# CONDITIONAL USE PERMIT & DESIGN REVIEW NARRATIVE

QT #1444 – SEC 83<sup>rd</sup> Ave & Glendale Ave  
Glendale, AZ

## **X. RESPONSES TO STAFF'S PRE-APPLICATION COMMENTS**

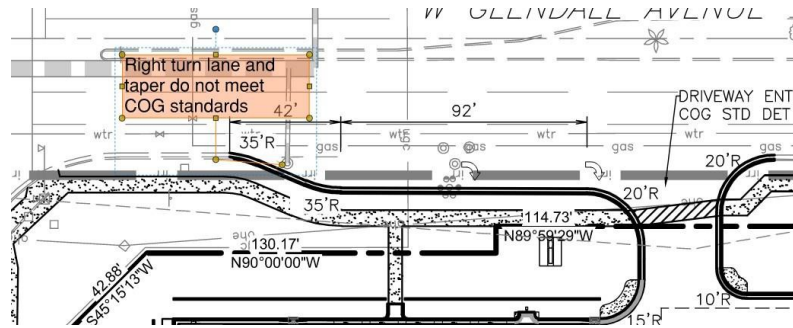
- ☒ Right turn deceleration lanes may be required in advance of the proposed driveway to the proposed site. The T.S. or the T.I.S. will confirm the need for the deceleration right lane based on volume of traffic that will be utilizing the driveway. The traffic study will also provide recommendation(s) on the required turn bay length. The City of Glendale's minimum turn bay length is 150'.

The City of Glendale requires right turn deceleration lanes on arterial roadways (83<sup>rd</sup> Ave) in advance of intersections with another arterial roadway (Glendale Ave).

- **Response:** Right turn lane has been added from 83<sup>rd</sup> Ave to Glendale Ave. Additional RTL's have been added to 83<sup>rd</sup> Ave and Glendale Ave driveways.

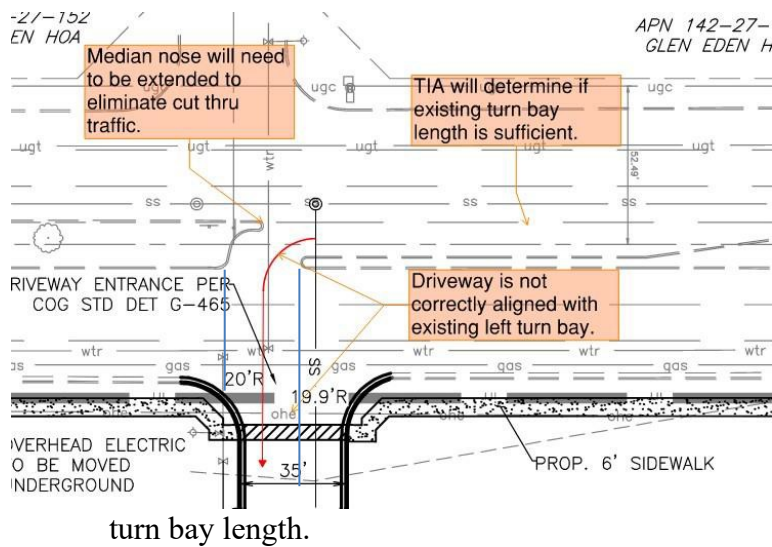
The taper distances shown for the proposed deceleration lanes into the development do not meet the City of Glendale's required lengths (150' for straight taper. 150' radius reverse curve taper may be used for less distance.)

Bus stop may be included in right turn decel lane.

- **Response:** RTL for Glendale Ave has been extended to intersection to allow space for bus stop.
  - ☒ A left turn lane may be required. The traffic study will also provide recommendation(s) on the required

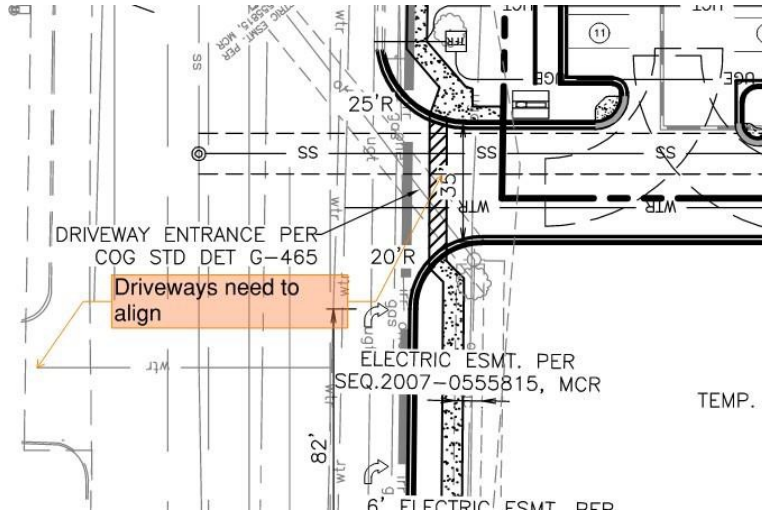
Include a turning radius drawing for left turning traffic to driveway.

- **Response:** Median nose will be extended and LTL opening expanded to line up with driveway location.
5. All effort shall be taken to align the proposed project full access intersection/driveways with existing intersections/driveways on the opposite side of the roadway thus avoiding creating offset intersection/driveways.

8. Min distance required between driveways:

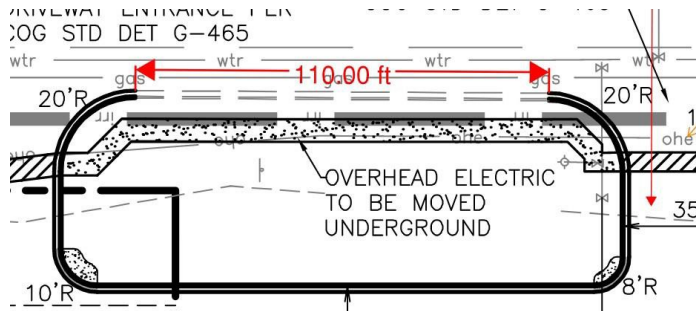
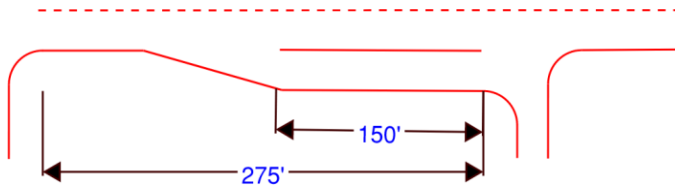
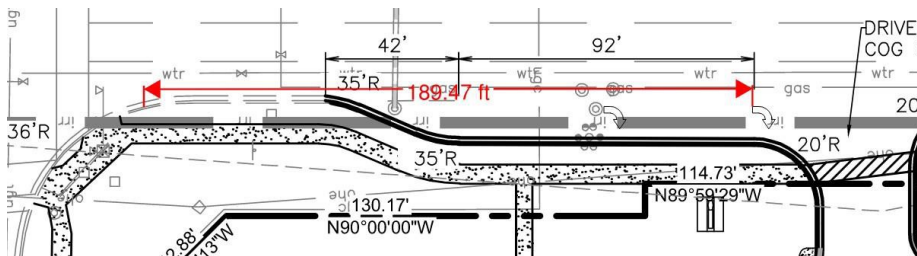
- ☒ 150' - When no turn lanes are required.

- ☒ 275' - When turn lanes are required.

- **Response:** Discussions during Pre-App, discussions with staff indicated turn lane would have to be compromised with the RTL to the west and the median opening to the east.

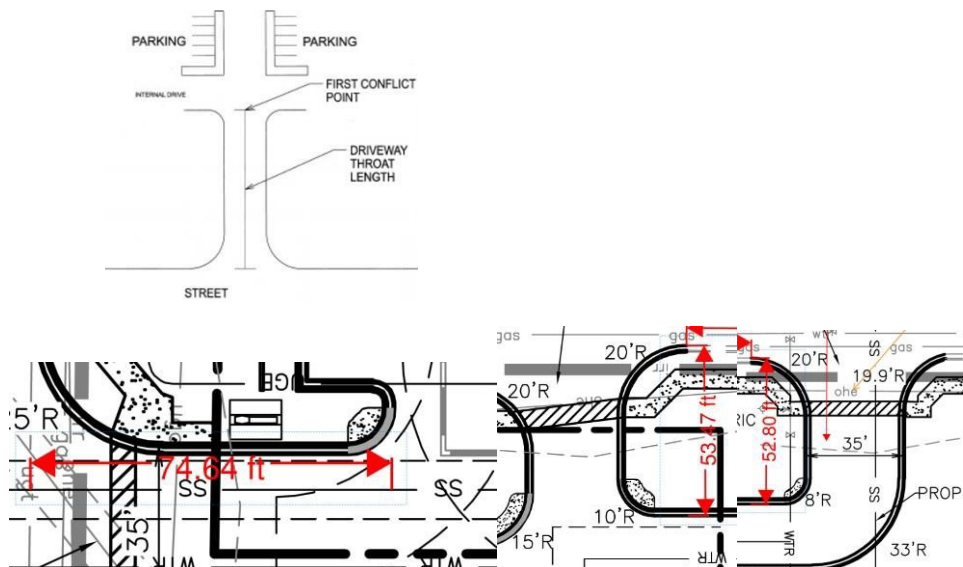
10.A 55' driveway "throat"/stacking distance free of drive aisles and parking spaces measured from the face of curb.

Please dimension stacking distances on DR/CD for verification.  
Scaled values shown may be slightly off.

• **Response:** Noted. Distances will be shown on CD's.

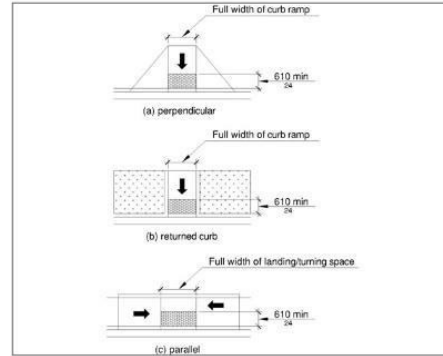
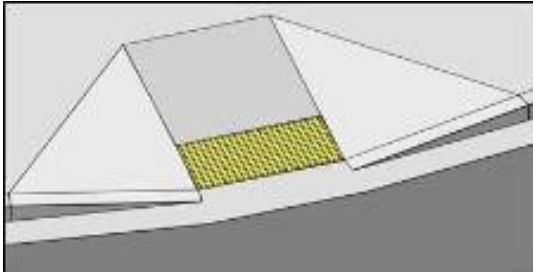
The Proposed ADA path passing through the fill up area is not ideal. Why not have a path to 83<sup>rd</sup> Ave instead?

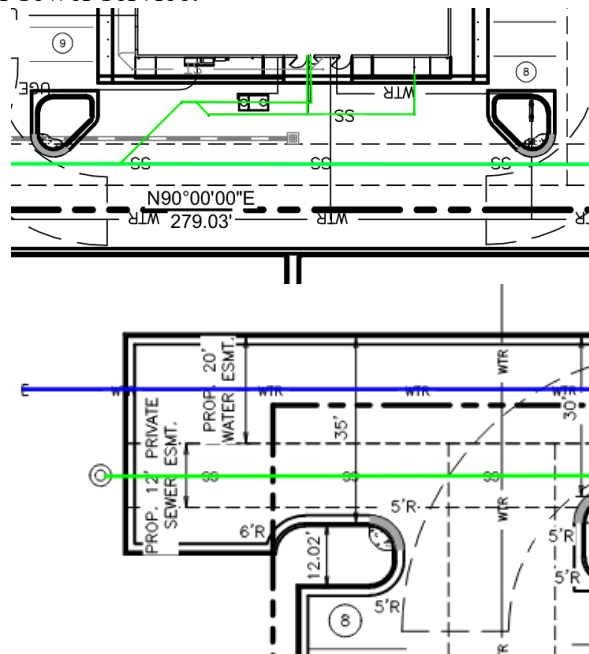
1. The QuikTrip development is proposing to tap into the proposed, on-site public 8- in main for domestic water and a fire line services. Will this development propose an additional tap and meter for the landscape irrigation? If not, landscape irrigation shall be taken off the domestic

line after the meter and incur additional sewer charges associated with the domestic water use.

- **Response:** A dedicated landscape meter & bfp will be installed adjacent to the domestic meter.
